## MEMORANDUM

**TO:** Wei Zeng, Georgia Environmental Protection Division  
**FROM:** Sorab Panday, GSI Environmental  
**RE:** Responses to Georgia EPD Modeling Questions

### EXECUTIVE SUMMARY

**WATER LEVEL DIFFERENCE BETWEEN SENSITIVITY CASE WITH HOLES IN BENTONITE LAYER AND PRE-MINING CONDITION**

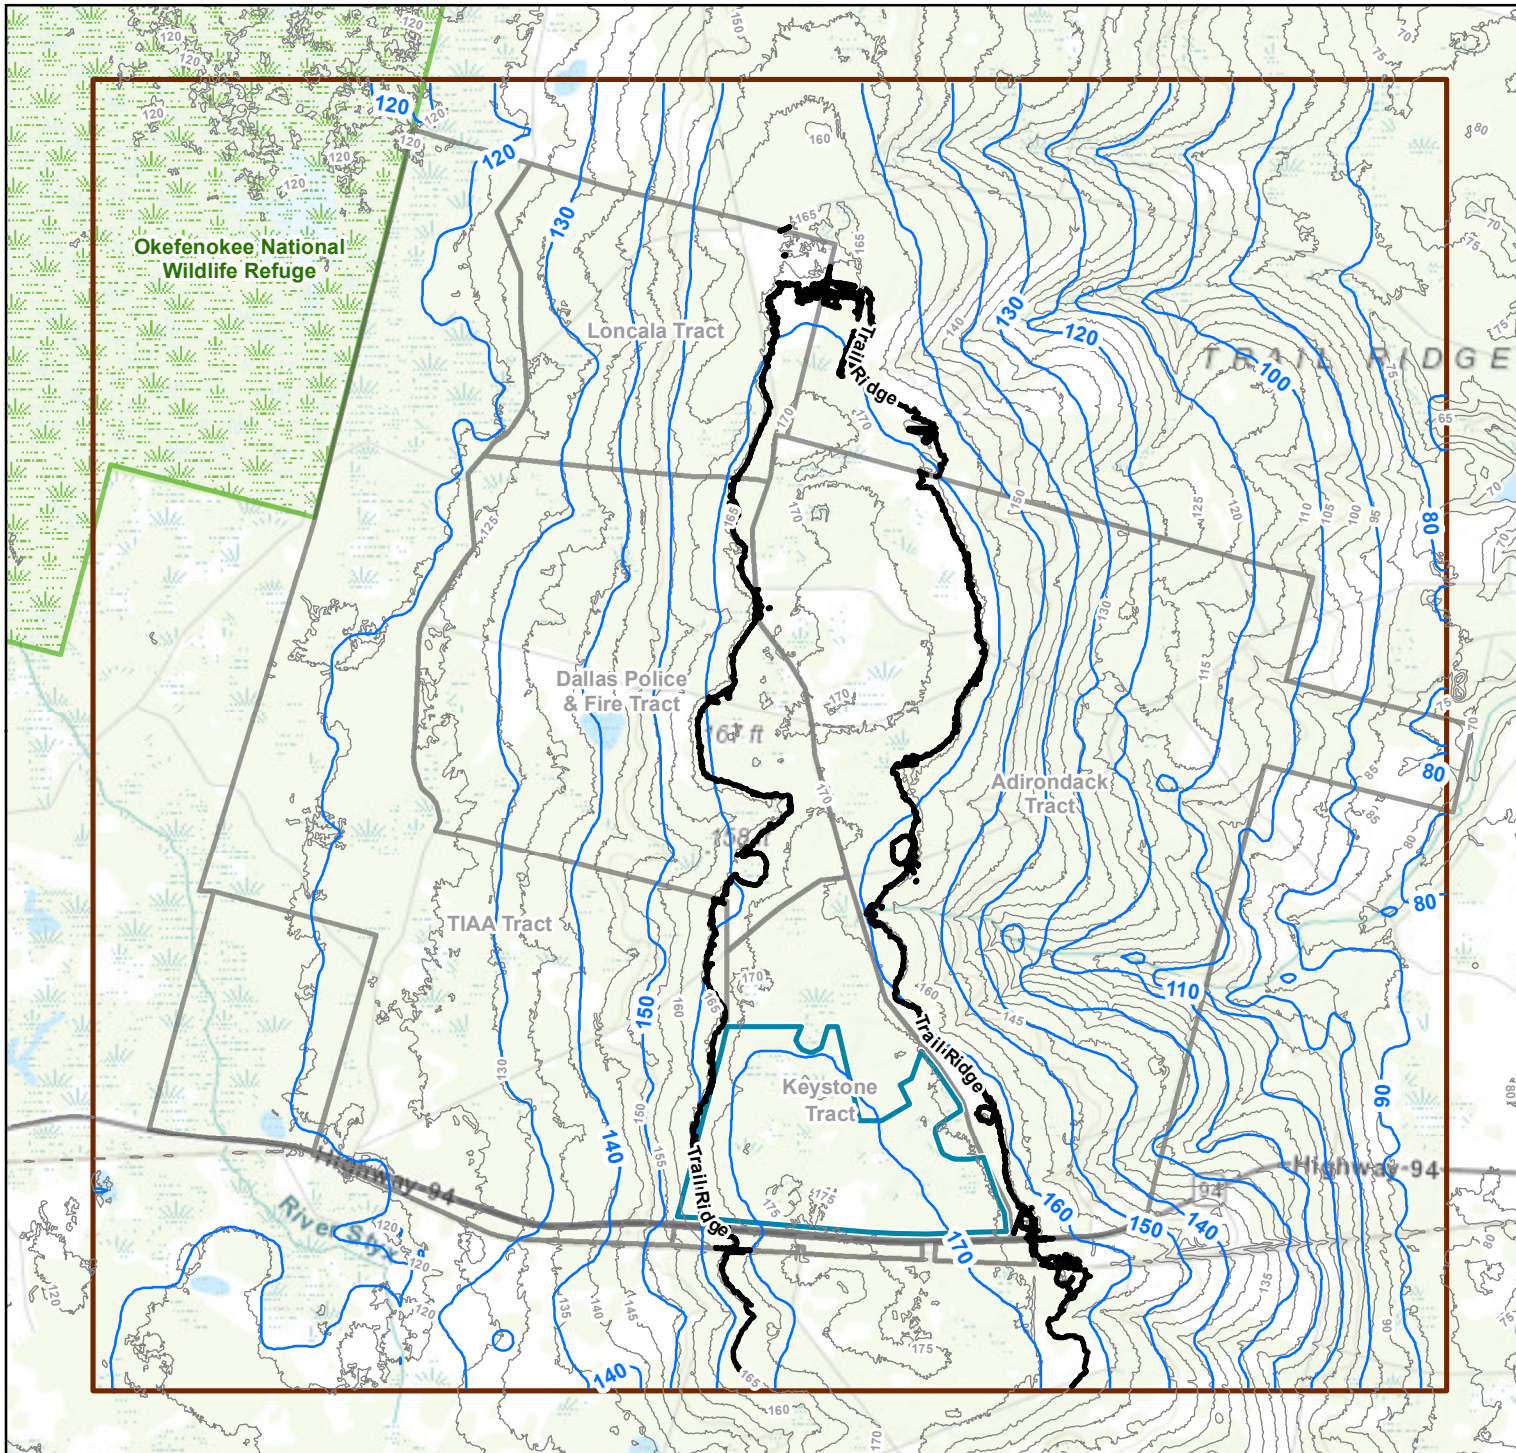
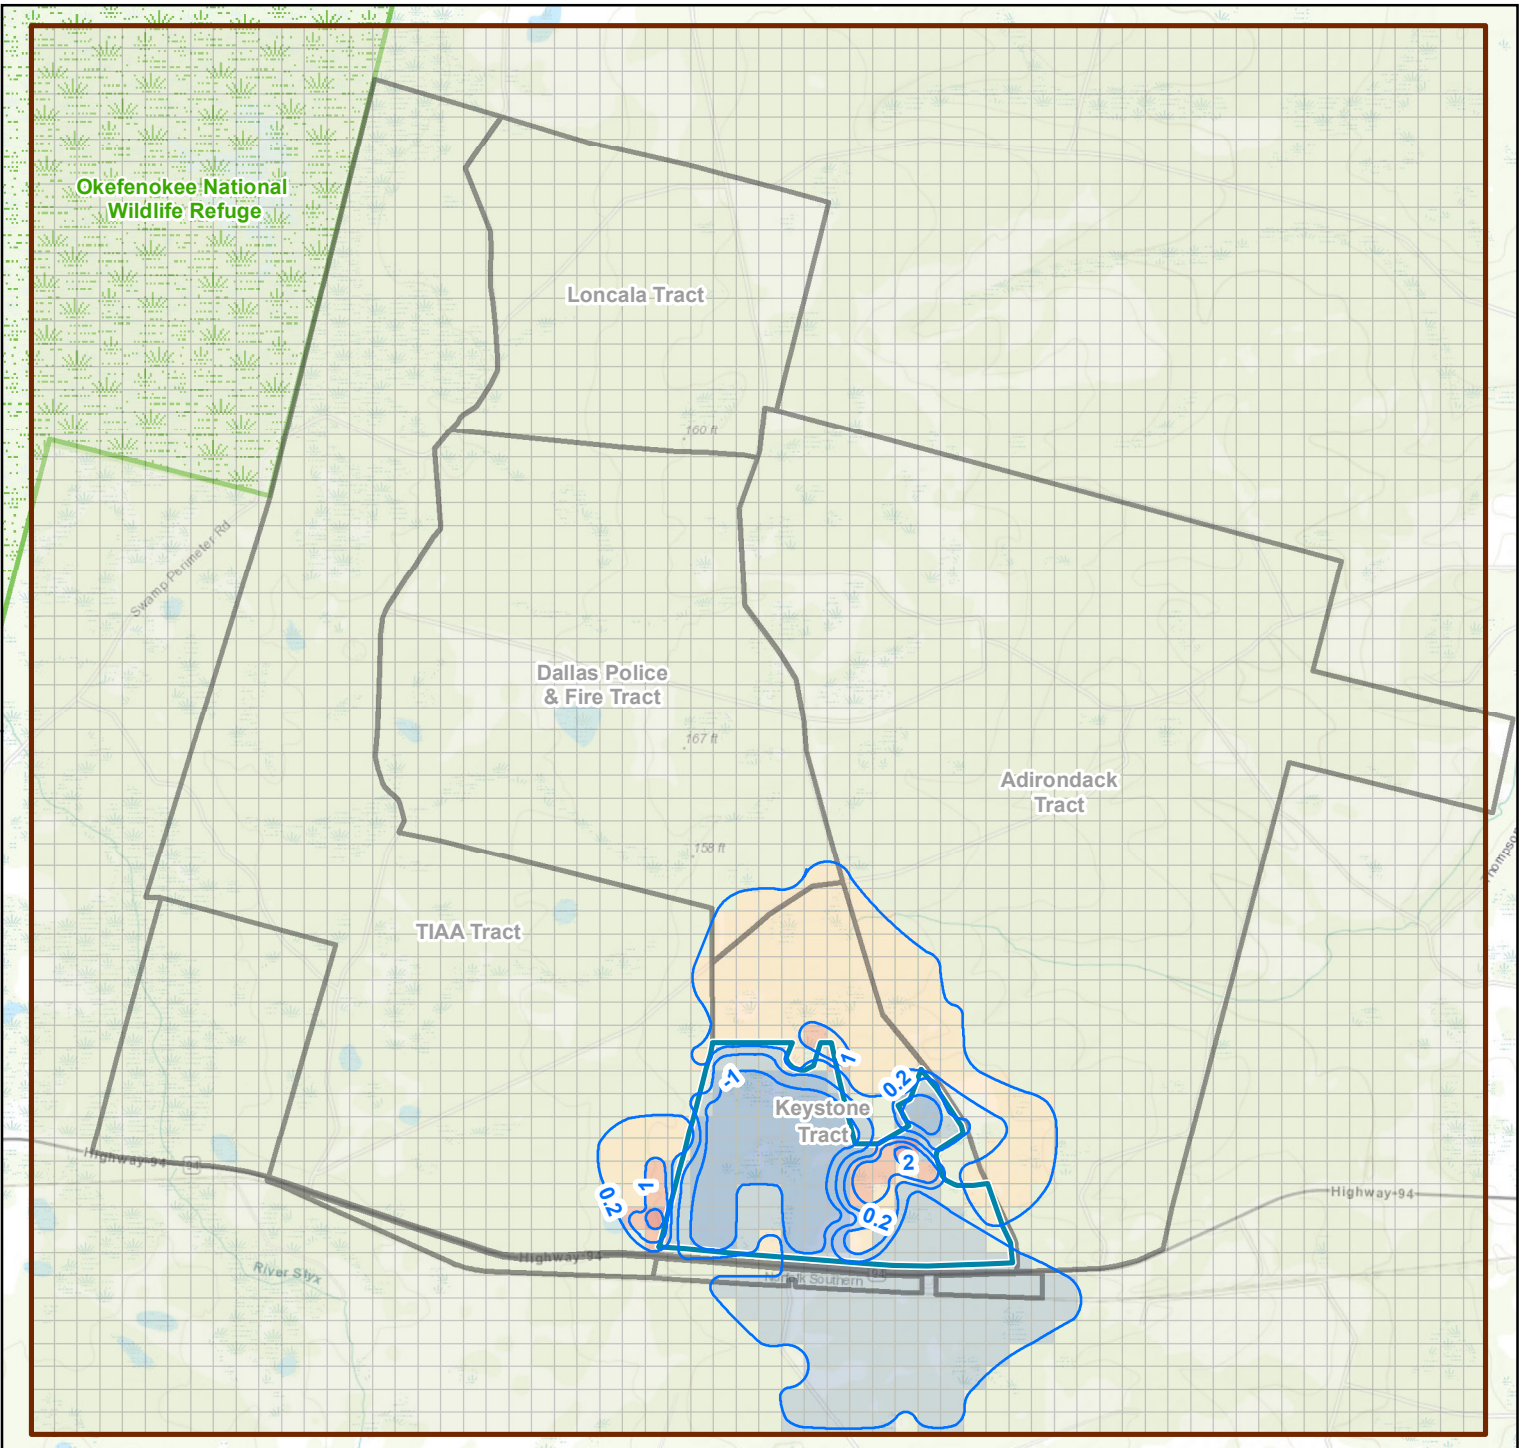
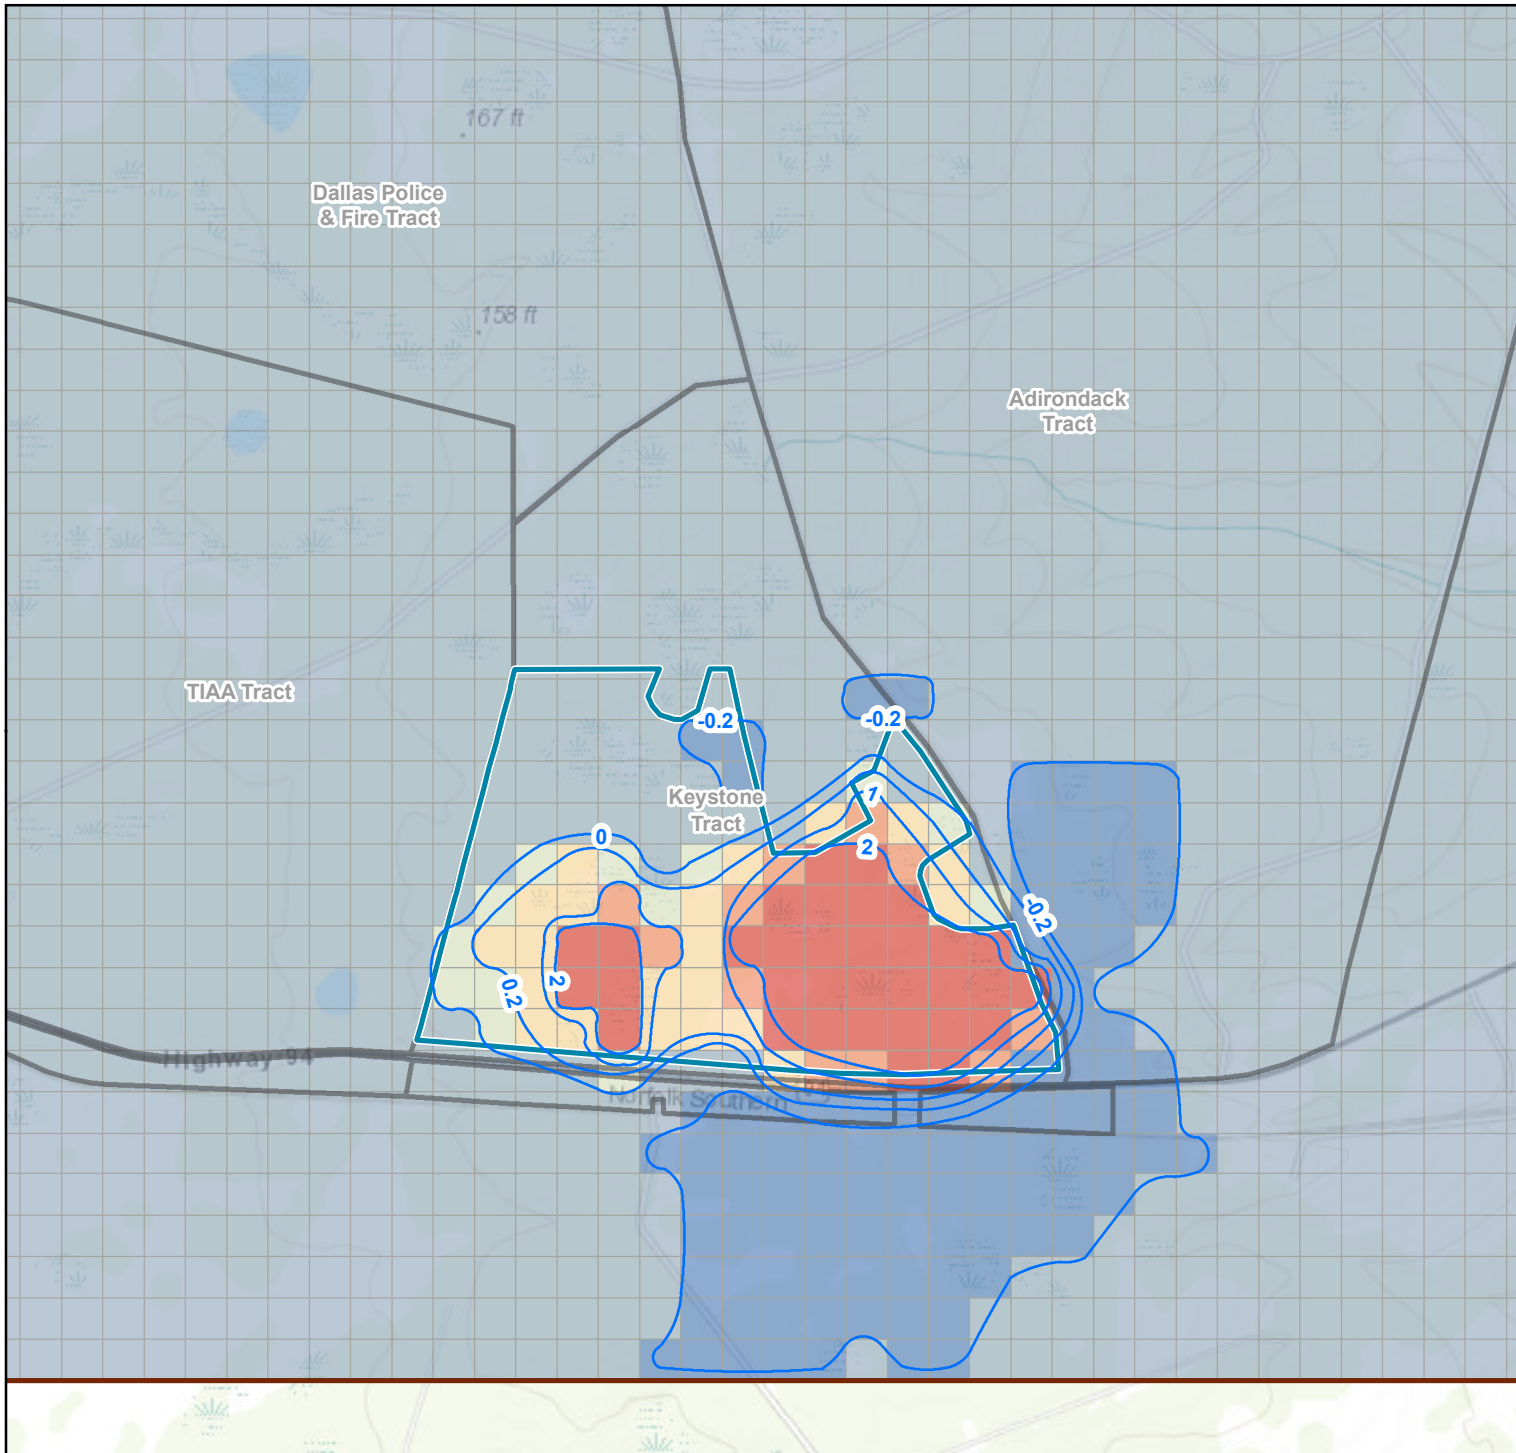
**Question 3:** In the model runs showing the post-mining condition with the soil amendment layer, was the bentonite layer placed throughout the proposed mining area during reclamation, and what would be the impact of "holes" in the bentonite layer where CBS does not exist?

A sensitivity study was conducted on the 10.9 % bentonite amendment model. **Figure 6** shows the layout of the holes in the bentonite layer (i.e., in locations where the calibrated model CBS hydraulic conductivity value was larger than the cutoff value of  $7.8 \times 10^{-4}$  ft/d). The hydraulic conductivity within these holes was set to 2.8 ft/d, which is the estimated value for the reclaimed sands. About 63% of the mined area is covered with bentonite while the remaining portion of the mined area was modeled with holes in the bentonite. **Figure 7** shows the water level contours for this case, indicating that water flows to the west, west of Trail Ridge, and to the east, east of Trail Ridge. **Figure 8** shows the water table difference for this sensitivity case compared to the pre-mining condition, indicating generally minimal water level changes (between approximately a 0.2 foot water level increase and a 0.99 foot water level decrease) across the majority of the site. Two locations, which coincide with the hole locations depicted on **Figure 6**, exhibited water level decreases of approximately 2.0 feet. **Figure 9** shows the water table difference between the sensitivity case (approximately 63% coverage of a 10.9% bentonite layer) compared to the simulation with a continuous 10.9% bentonite layer depicted in **Figure 5**. As can be seen, the holes provide a water level drop of between 2.01 and 6.08 feet across the mining area. This difference is primarily attributable to water level increases relative to the pre-mining condition caused by the continuous bentonite layer.

Overall, the analysis shows that the placement and distribution of the bentonite layer has a negligible effect on wetlands west of the mine site. **Table 1** shows the water balance for the various cases. As can be seen, there are negligible changes in discharge to the wetlands compared to the pre-mining case, regardless of the bentonite layer structure.
